Client Name - Capital 38
Job No. 4677

21 Bloomsbury St

Condition 4 Update

Historic England - Point 5

Crittal Windows

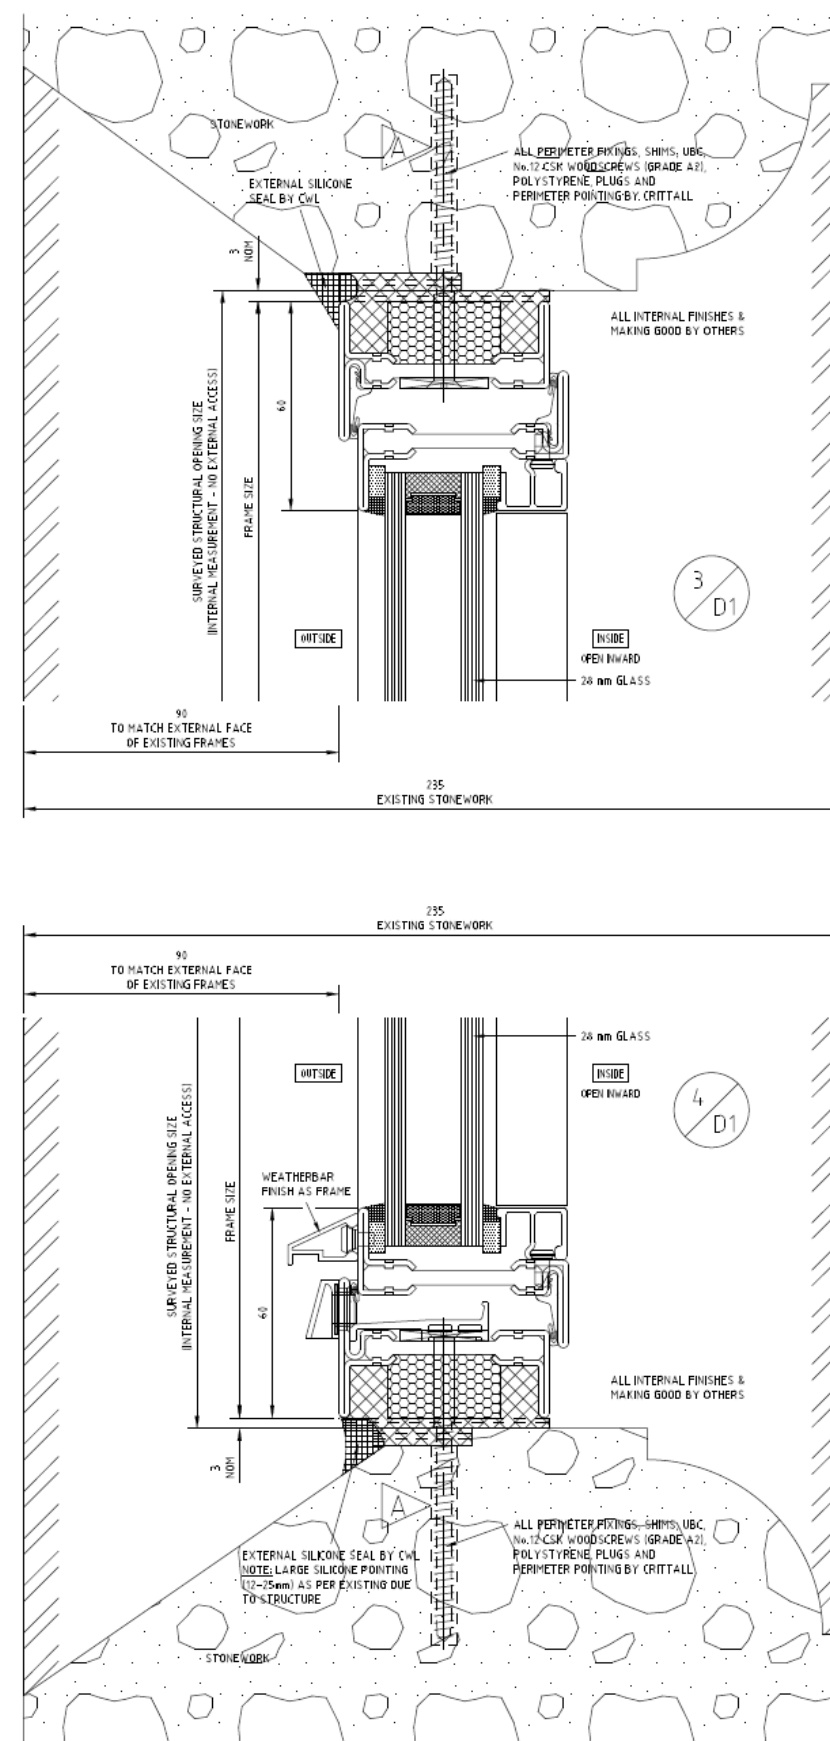
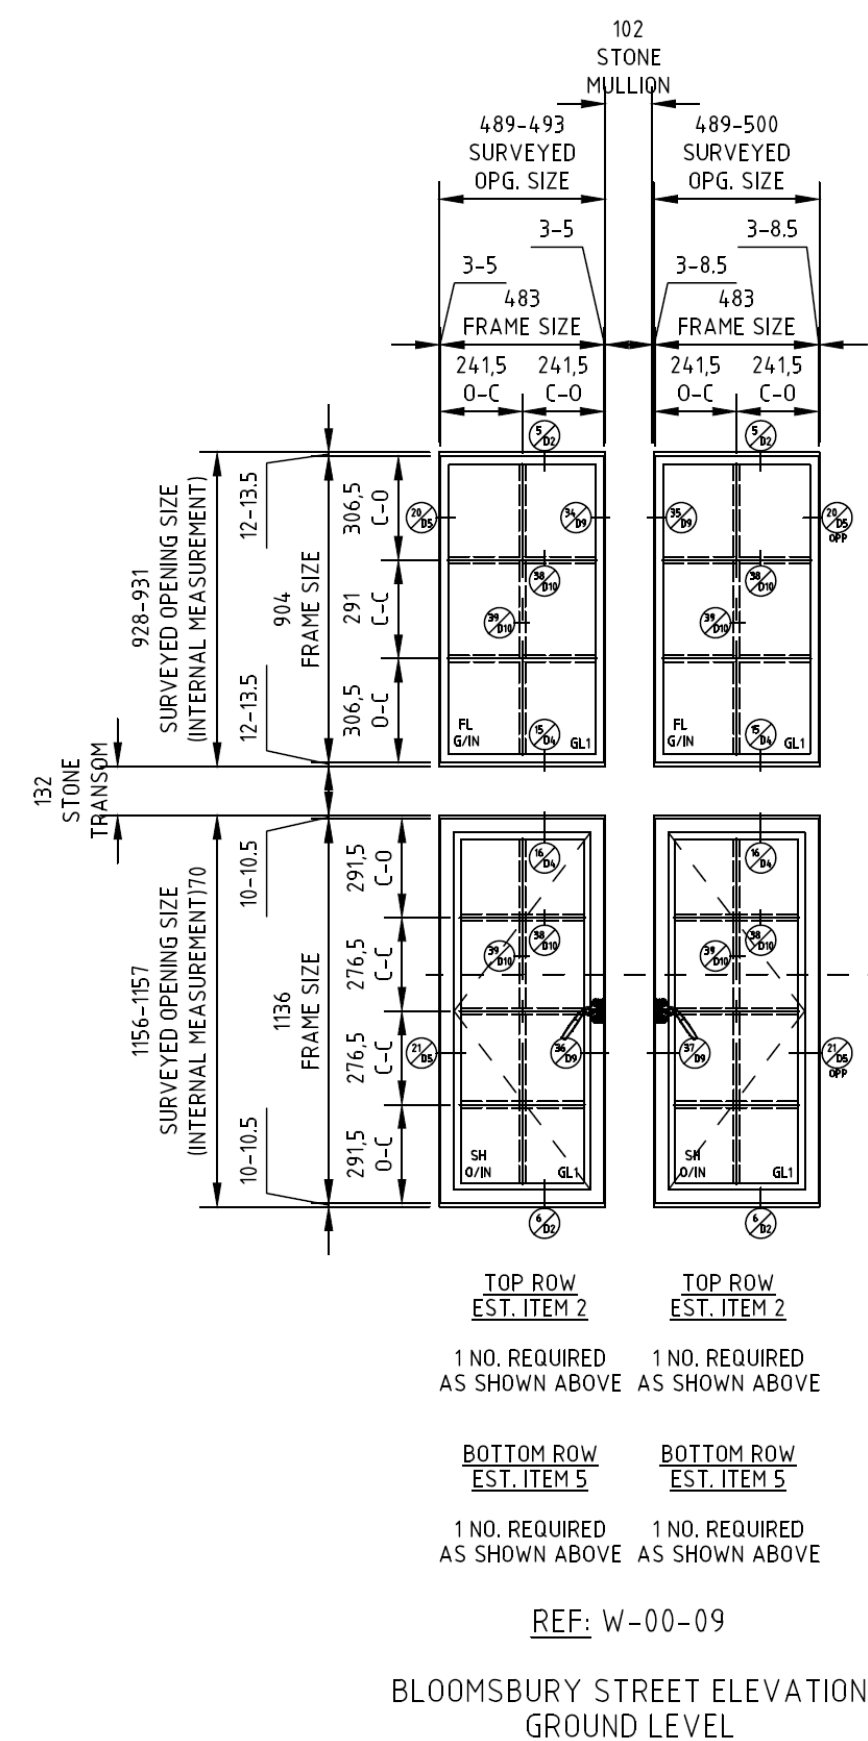
This clarifies the base case of the existing metal framed DGU's all to be replaced illustrating the lower quality plant on beading externally that is not reflective of the typical assembly of these windows historically and which does not for any part of the glazing proposals. These windows will have formed part of the development during the early 1990's.

Crittall Windows

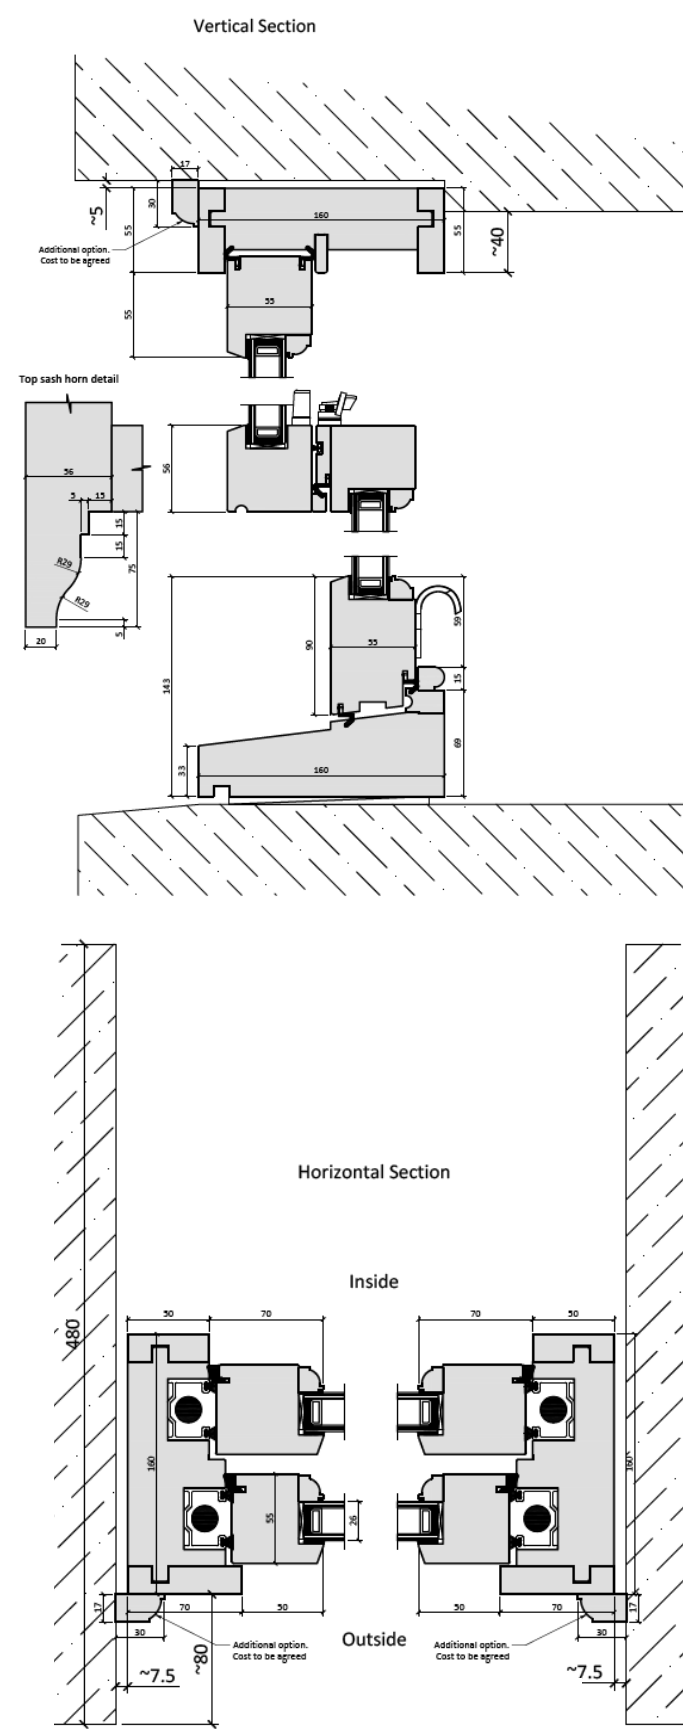
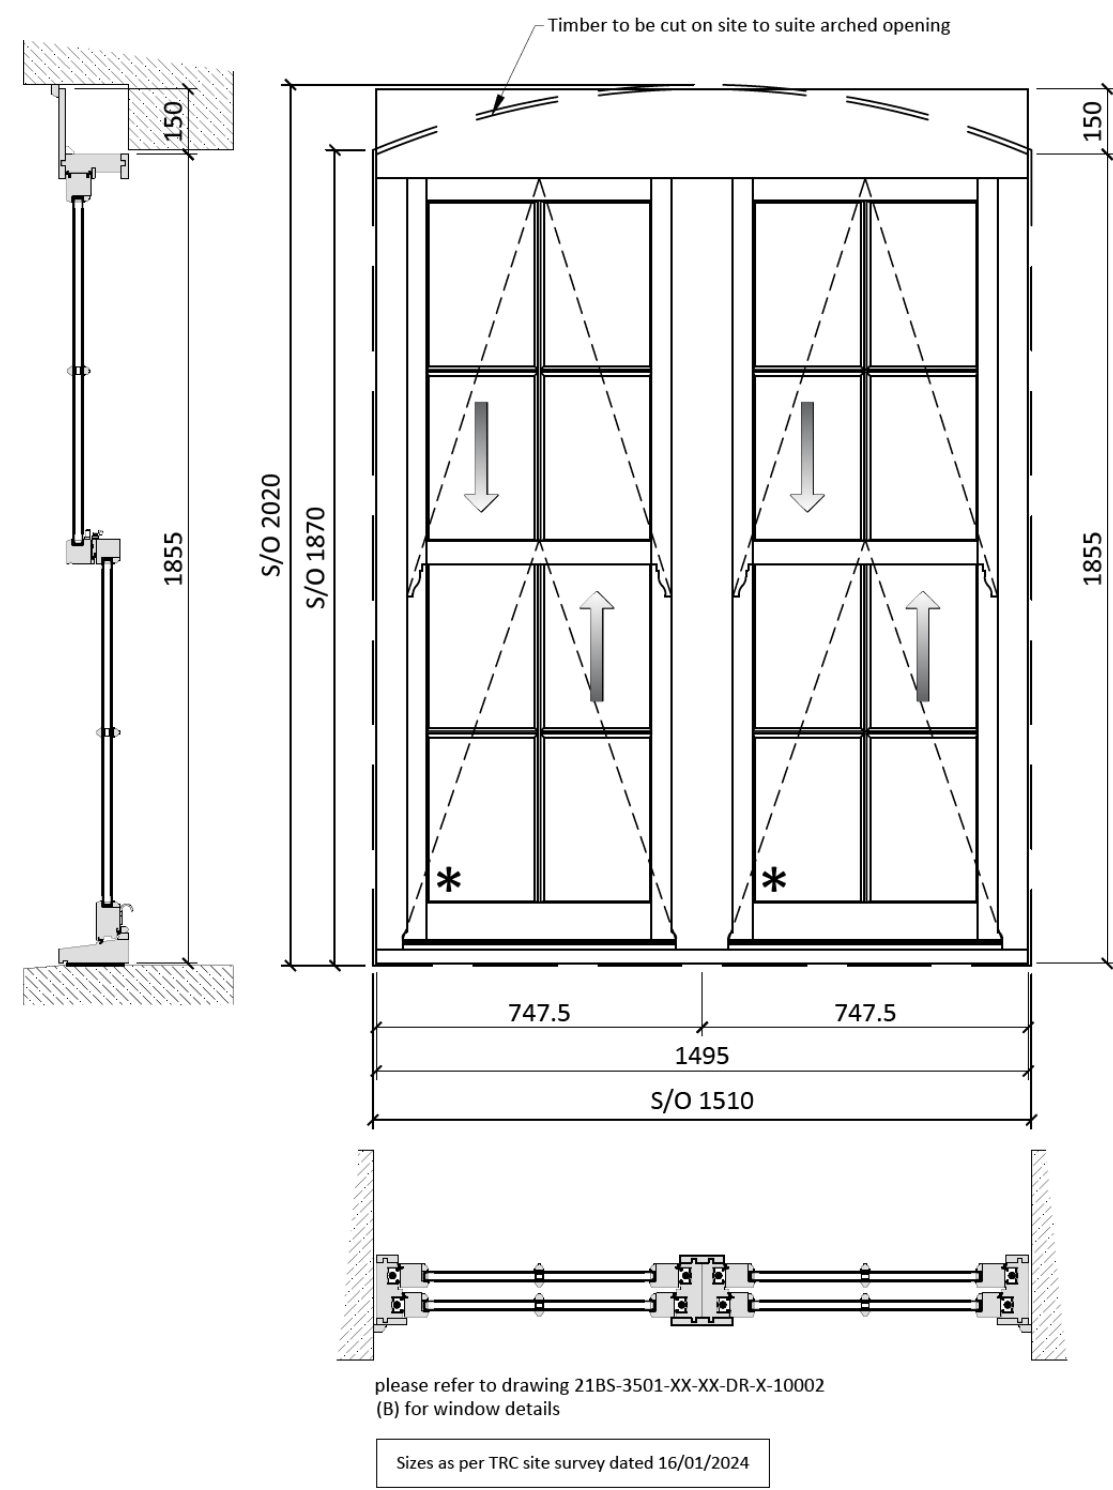
It is very important that the building performs both thermally and from an air tightness perspective. As metal windows have high thermal transfer they need to be broken to mitigate condensation build up internally. This as a general rule thickens the profile width + depth to accommodate. The original glazing would have had poorly performing small single glazed panes only required lighter profiles in their general construction to hold them in pace and due to the volume of beading (often putty) these would also leak air. To sub divide the overall window pane into smaller (leaded light) panes would in result in the glazing bars becoming much fatter and visually would move away from the generally slender nature of leaded lights imposing inadequate proportions in replicating a more traditional steel window of this type. The manufactures are some of the original manufacturers of these early steel windows and have gone to long lengths to offer a technically high performing specification that visually carries the look and proportions of its predecessors. The early steel framed windows were single glazed and unbroken thermally resulting in poor U-Values (heat transmission and increase energy use) or G-Values (solar control increasing energy use). This design is required to take consideration given to a broader view on the elevation as whole and the original visual appearance of steel windows. Given the stringent thermal performance of regulations the approach taken to sub divide the pane with internal spacer bars which read through external plant on sections as though singular panes is the only way to achieve the proportions and balance all the requirements on these windows.

Sash Windows

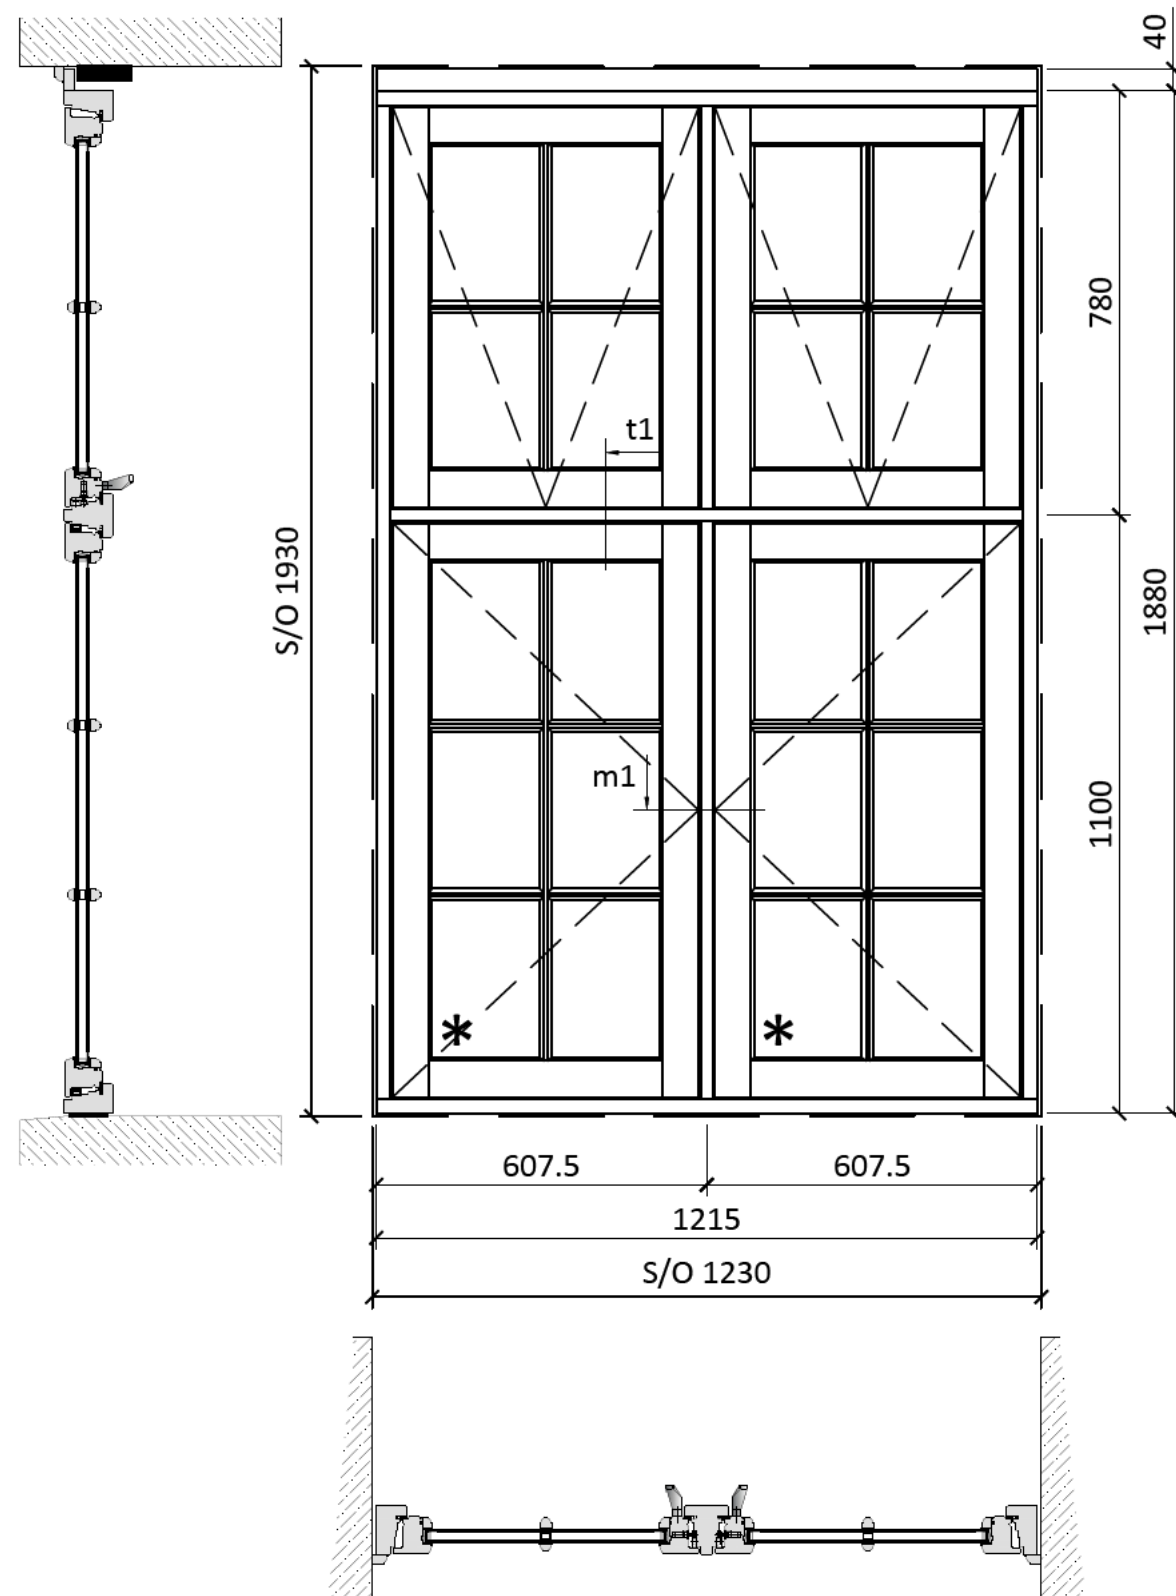
Reviewing the criteria on these windows the same conclusions on the balance is required to meet the visual heritage requirements from a materiality, geometry and proportion perspective whilst delivering the technical requirement demanded of current regulations. The Case study illustrates the overall appearance and trust that whilst using DGU's and breaking the pane down with internal spacer bars married with external sub divisions to replicate the singular pane appearance there is no perceptible double reflection occurring in the DGU and the elevation holistically in keeping (historically) by employing this approach.

The proposed elevation shown demonstrates an overall balance to the geometry of the windows that is in keeping with the existing overall aesthetic of the facade.

Casement Windows

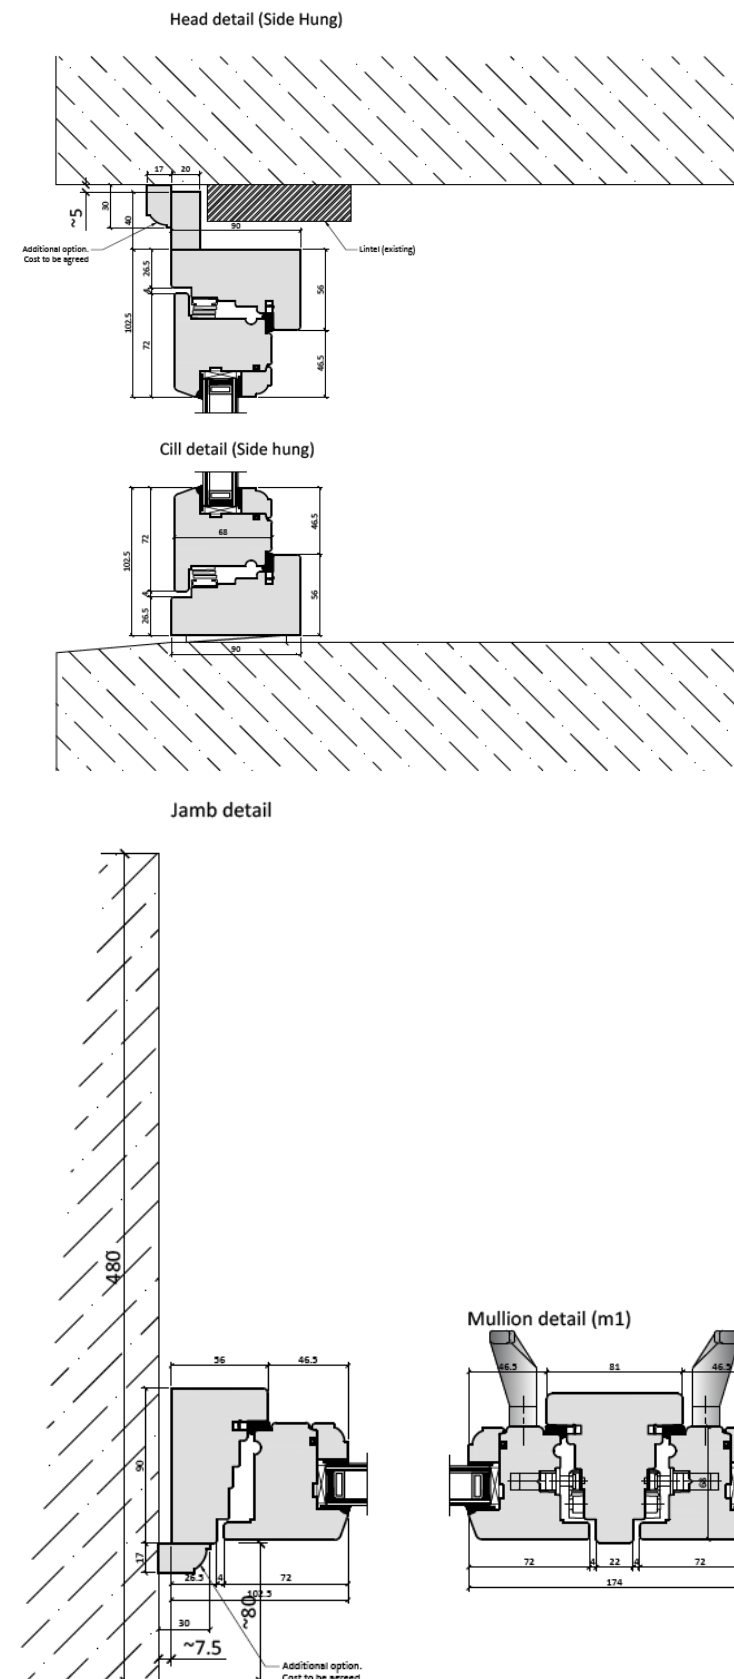
Reviewing the criteria on these windows the same conclusions on the balance is required to meet the visual heritage requirements from a materiality, geometry and proportion perspective whilst delivering the technical requirement demanded of current regulations. The Case study illustrates the overall appearance and trust that whilst using DGU's and breaking the pane down with internal spacer bars married with external sub divisions to replicate the singular pane appearance there is no perceptible double reflection occurring in the DGU and the elevation holistically in keeping (historically) by employing this approach.

The proposed elevation shown demonstrates an overall balance to the geometry of the windows that is in keeping with the existing overall aesthetic of the facade.
